# Access Compliance Report

## Public Rights-of-Way

### (Curb Ramps)

Intersection ID: 10006798	Main Street: HOLBROOK_DR	Cross Street: N SHARON AMITY RD	Location:	NW
ADA ID: 8C9BFE0BB452	Ramp Type: Perp	Initial Pass/Fail: Fail	Overall Compliance: No	Severity Score: 1.25

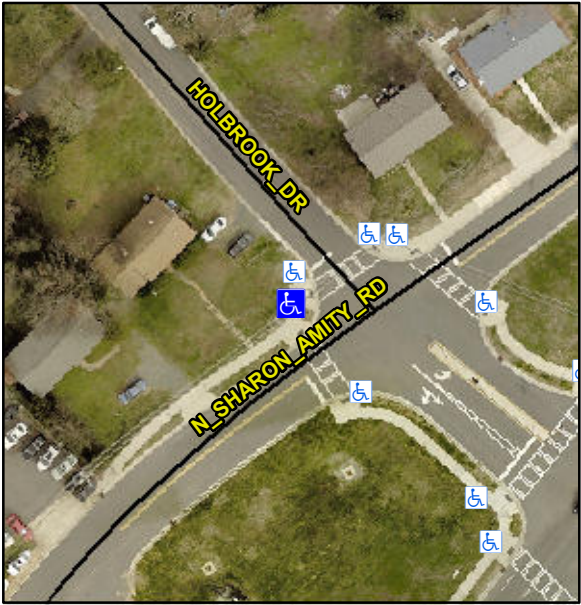
Codes/Mitigation Info/Possible Solution			Field Measurements/Component Compliance		
	Possible Solutions:		<b>Compliance</b>	<b>Description</b>	<b>Data</b>
	<b>Remove &amp; Replace Entire Ramp.</b>		<b>Yes</b>	Ramp Length (in)	25.0
			<b>N/A</b>	Ramp Width (in)	59.5
			<b>N/A</b>	Flare Type LT	N/A
			<b>N/A</b>	Flare Slope LT (%)	N/A
			<b>N/A</b>	Flare Traversable LT?	N/A
			<b>N/A</b>	Flare Type RT	N/A
			<b>N/A</b>	Flare Slope RT (%)	N/A
			<b>N/A</b>	Flare Traversable RT?	N/A
			<b>N/A</b>	DWS Provided?	N/A
<p>Surveyor Notes:</p> <p><b>N/A</b></p>			<b>N/A</b>	DWS Contrast?	N/A
			<b>N/A</b>	DWS Length (in)	N/A
			<b>N/A</b>	DWS Full Width?	N/A
			<b>N/A</b>	DWS Offset (in)	N/A
			<b>N/A</b>	Gutter Ponding?	N/A
			<b>N/A</b>	Gutter X Slope (%)	N/A
			<b>N/A</b>	Gutter Lip Ht (in)	N/A
			<b>N/A</b>	Painted X Walk1?	Yes
			<b>N/A</b>	X Walk 1 Direction	To S
			<b>N/A</b>	X Walk 1 Width (in)	112.5
<p>PROW/ADA:</p> <p><b>Not Found, R304.5.3</b></p>			<b>N/A</b>	X Walk 1 Slope (%)	5.8

<b>N/A</b>	X Walk 1 X Slope (%)	1.8
			<b>N/A</b>	Ramp inside XWalk1?	Yes
			<b>N/A</b>	Road Slope (%)	N/A
			<b>N/A</b>	Road X Slope (%)	N/A
			<b>N/A</b>	Any Obstructions?	N/A
			<b>N/A</b>	Obstruction Type	
			<b>N/A</b>	Clear Space?	N/A
			<b>N/A</b>	Clear Space to XWalk (in)	N/A
			<b>N/A</b>	Storm Grate/Utility Hazard?	N/A
<p>Total Cost:</p> <p><b>\$ 1850.00</b></p>			<b>N/A</b>	Storm Grate/Utility Type	
			<b>N/A</b>	Surface Condition? (G/P)	Good
